**Project Name:** Gaylord Community Schools SF3.8 – 2024 Sinking Fund Projects

GCS SF3.8 Bid Package #4 – BOECC Generator & ATS Installation

Prepared by: Justin Kowatch, PE Addendum Number: #1 – Electrical Items

#### **ADDENDUM**

**E0.1**

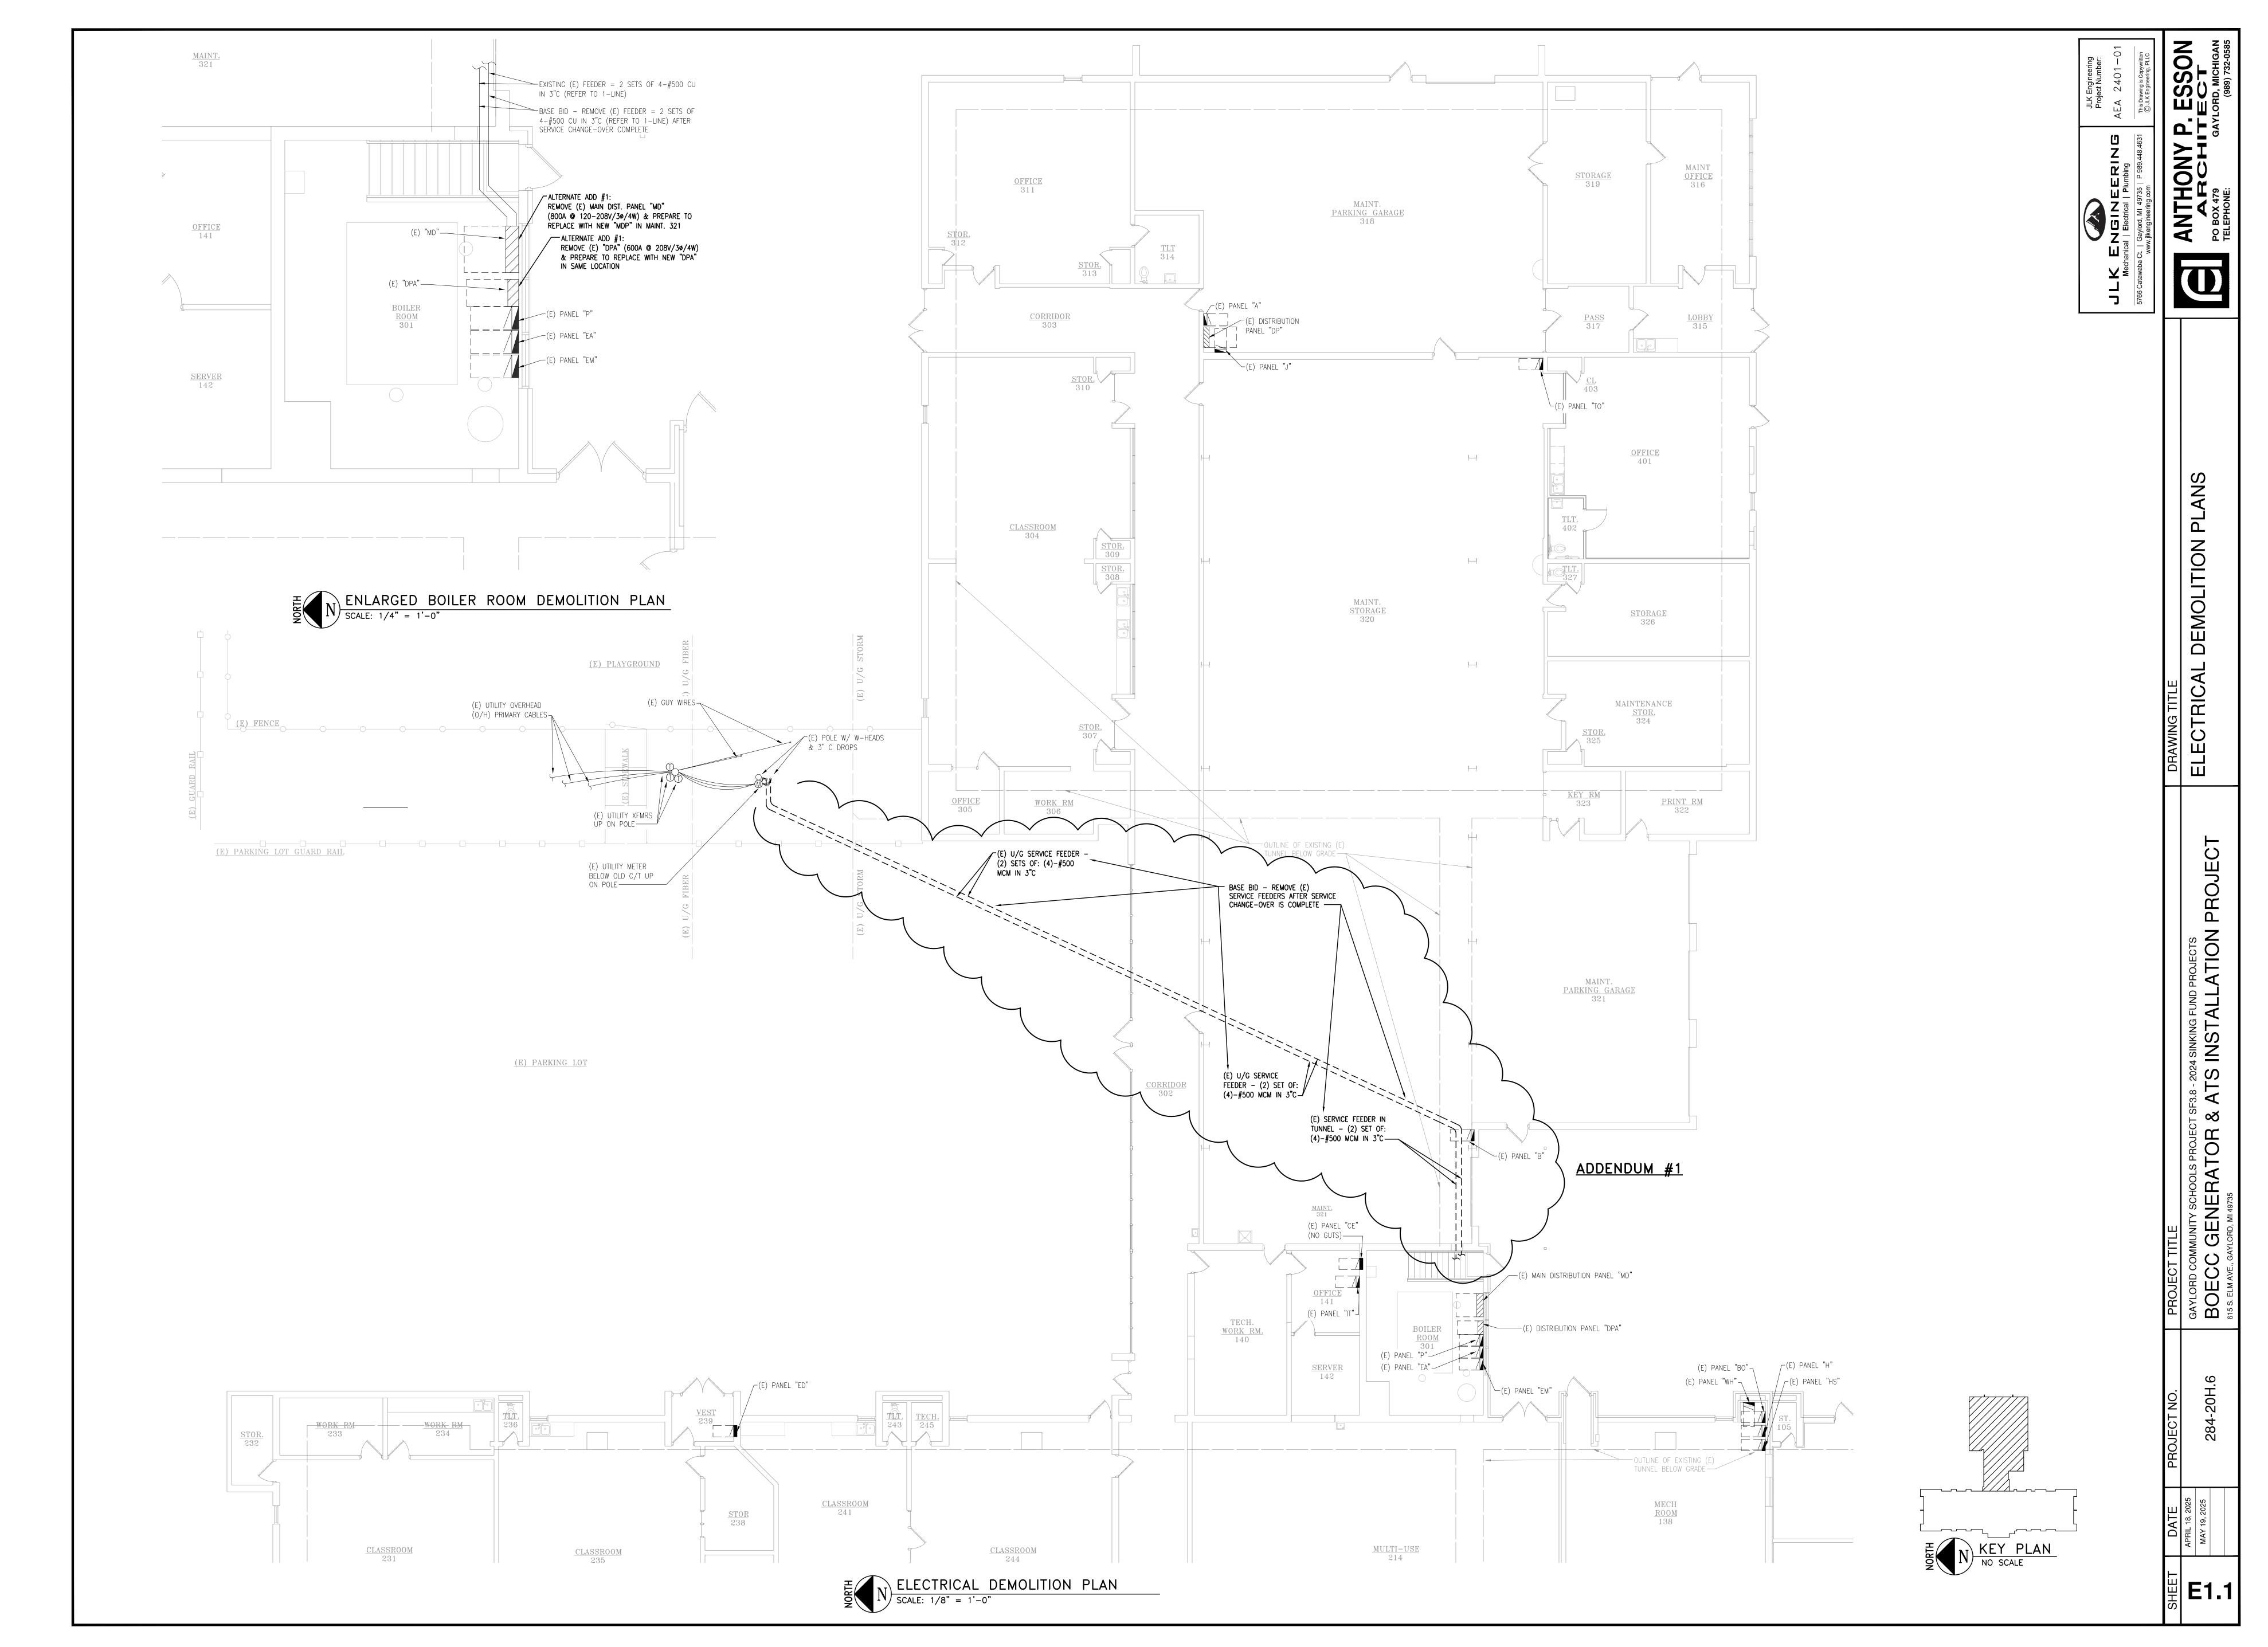
Drawing E0.1 – Modified Electrical Drawing Index to include new drawing E3.2.
